## WORK ORDER NON-CONFORMANCE / UPDATE

Work Order: <u>97672</u>	<b>DISPOSITION</b> Rework <input type="checkbox"/> Scrap <input type="checkbox"/> Use-as-is <input checked="" type="checkbox"/> Work Order Update <input type="checkbox"/>	<b>AGAINST DEPARTMENT/PROCESS</b>			
Part No. <u>D3488-042</u>		Skid-tube <input checked="" type="checkbox"/>	Crosstube <input type="checkbox"/>	Water Jet <input type="checkbox"/>	Engineering <input type="checkbox"/>
NCR No. <u>13-2513</u>		Machining <input checked="" type="checkbox"/>	Small Fab <input type="checkbox"/>	Prod. Eng. Coord. <input type="checkbox"/>	Quality <input type="checkbox"/>
		Thermoforming <input type="checkbox"/>	Finishing <input type="checkbox"/>	Rec/Store/Packaging <input type="checkbox"/>	Other <input type="checkbox"/>
		Large Fab <input type="checkbox"/>	Composite <input type="checkbox"/>	Supplier <input type="checkbox"/>

DART AEROSPACE LTD		Work Order:	97672
Description: Blade Fitting, RH / Turning Detail for D3488-1/-2		Part Number:	D3488-2
Inspection Dwg: D3488 / DSK101 Rev: B / D		Page 1 of 2

D3488-041/-042 BLADE FITTING ASSEMBLY PARTS LIST

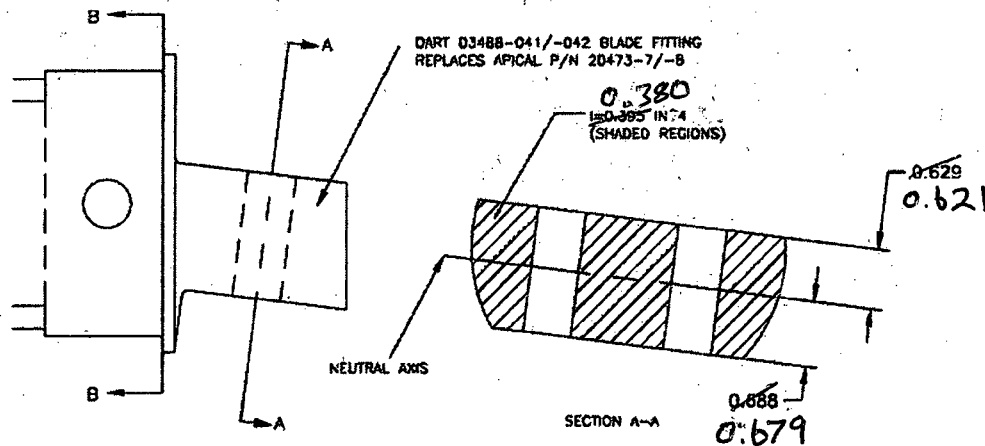
Root Cause	Date	Step	Qty	Description of work order update or Non-conformance	Initial Chief Eng	Action Description	Sign & Date	Verification	QC Inspector
Doc/Data	13/3/18	120	1	Dim 1.317 is 1.300 2.c. operator error	CP 13/3/18	Acceptable per attached S.R.	CP 13/3/18	DAS 08 13/03/19	DAS 16 13/03/20
Equip/Tooling									
Operator									
Material									
Setup									
Other									
Process									
Supplier									
Training									
Unapproved

The Dart D3488-041/-042 blade fitting replaces the Apical P/N 20473-7/-8 blade fitting. On page 3.7 of the Apical Report AI355-7 (see Reference 1) the moment in Section Y-Y is 29083 lb-in. This section of the Dart D3488-041/-042 blade fitting has different geometry than the Apical blade fitting, the longitudinal location however has not changed (Section A-A), therefore the moment applied to the Dart blade fitting at Section A-A is the same moment as Section Y-Y. The following calculation shows that the Dart blade fitting can withstand this bending moment.

Component	Dart D3488-041/-042
Material	7075-T7351 per QQ-A-225/9
Ftu Ultimate Tensile Strength	68000 PSI
(M) Moment at Section A-A	29083 lb-in (from Apical Report AI355-7)
(I) Moment of Inertia of Section A-A	0.395 in <sup>4</sup> (from AutoCAD)
(C) Distance to outer fibers (higher number used, worst case)	0.688 in (from AutoCAD)
Stress (MC/I)	50656 PSI
Margin of Safety (Ultimate) (Ftu/Stress)-1	0.34

0.380 (AutoCAD)

0.679 (AutoCAD)

51,966 PSI

0.31 ∴ OK
